**East Malling and  
Larkfield, Aylesford,  
Ditton**

**9 March 2026**

**TM/24/00372/OAEA**

**Proposal:** Outline planning application with all matters reserved (except for access, which is to include the Sustainable Movement Corridor from New Road East Malling to Kiln Barn Road) for development of land to west of Hermitage Lane and East of Kiln Barn Road comprised of: a residential-led development of up to 1,300 dwellings including affordable housing; a new village centre including a primary school; ancillary commercial, community and employment floorspace; strategic open space, parkland, child play provision and sustainable drainage infrastructure; new access points and associated transport infrastructure, including demolition of existing vacant buildings. Application supported by an Environmental Statement.

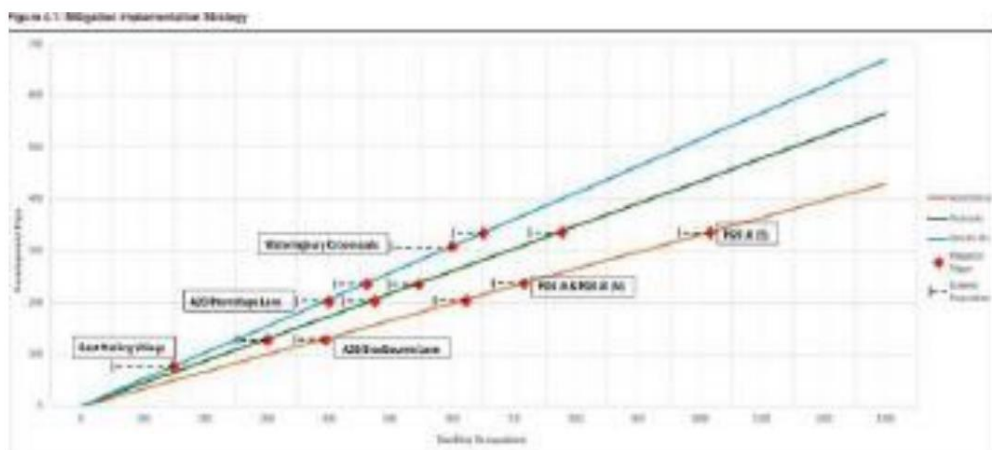
5.1552 45. That D&P strategy depends on subsequent monitoring of actual traffic flows.

5.1553 46. Transport Assessment Vol 1 – Executive Summary contains, at paragraphs 8.1.5 to 8.1.7 (inclusive), with our highlighting:
